Rev A: May 28 2015:Changed application box.

EGR TEMPERATURE SENSOR REPLACEMENT AND HARNESS ROUTING Prevost vehicles

Special Bulletin

SP15-322A

Figure 1 Location on engine.

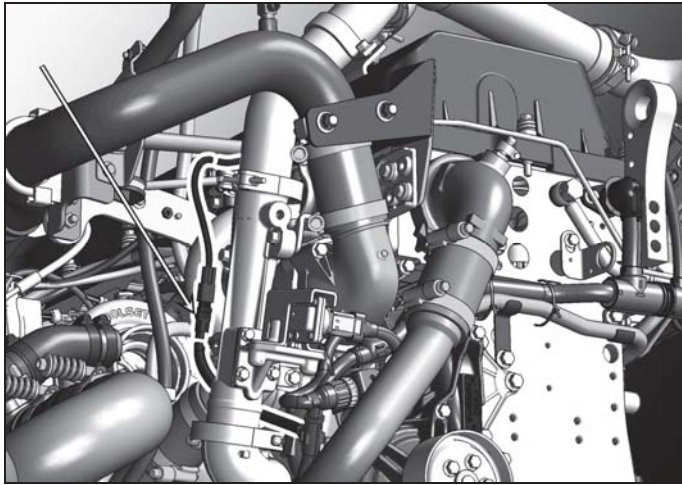
- 1) On the engine, road side, locate this branch of the engine harness.

Figure 3

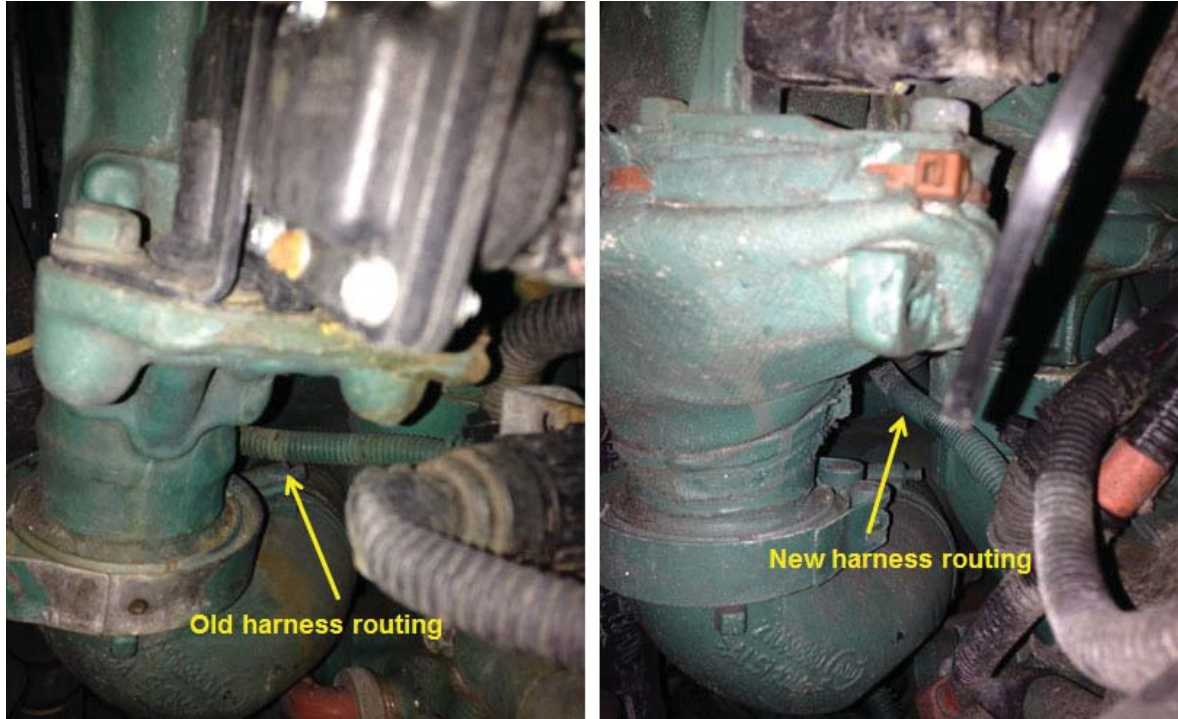
- 3) Disconnect engine harness lead from EGR temperature sensor and pull down to allow re-routing.
- 4) Reroute it back up through the inboard side of the lower coolant transfer pipe and EGR cooler Exhaust outlet pipe.

Figure 4

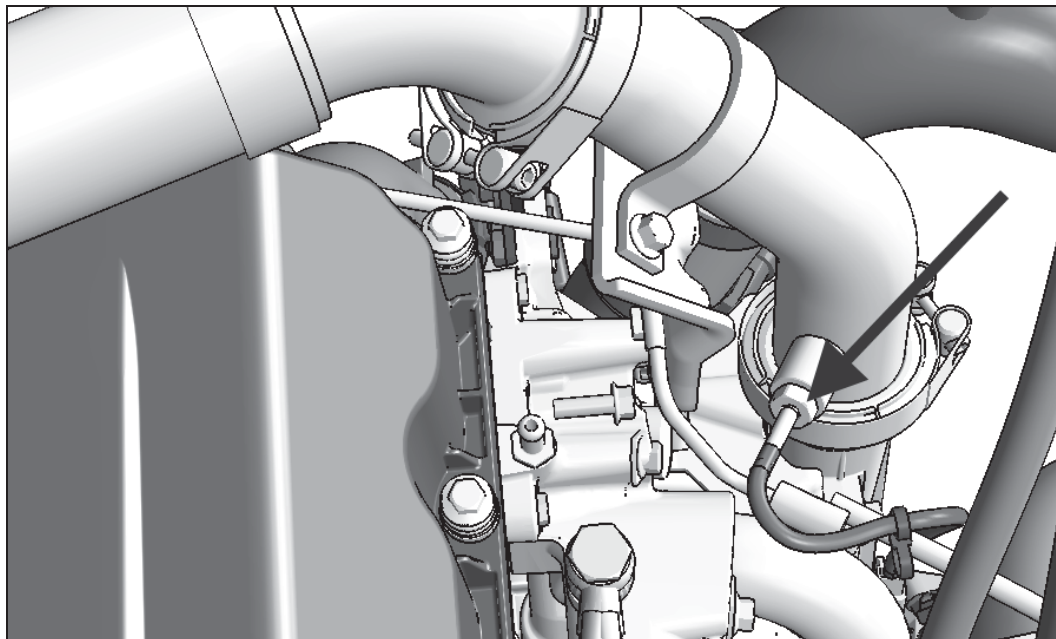
- 5) Replace the EGR temperature sensor with a new #21164790 (Tighten to 33 lbf-ft) then connect to harness

Figure 5

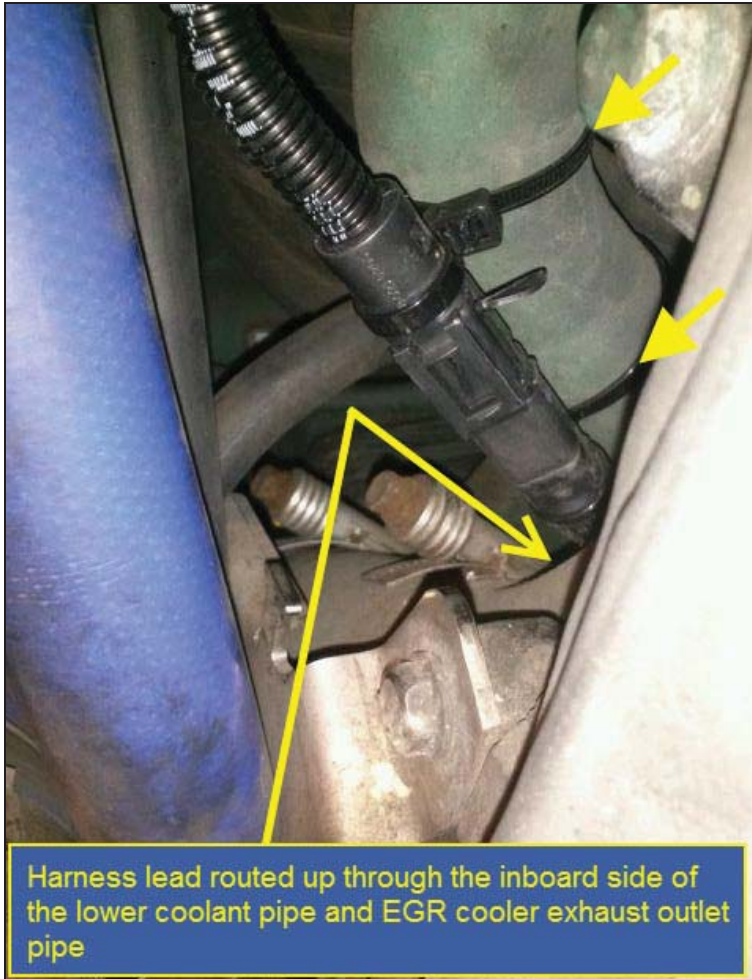
- 6) Secure to the EGR cooler coolant return pipe with supplied cable ties # 507664 (Fig. 2; 3)
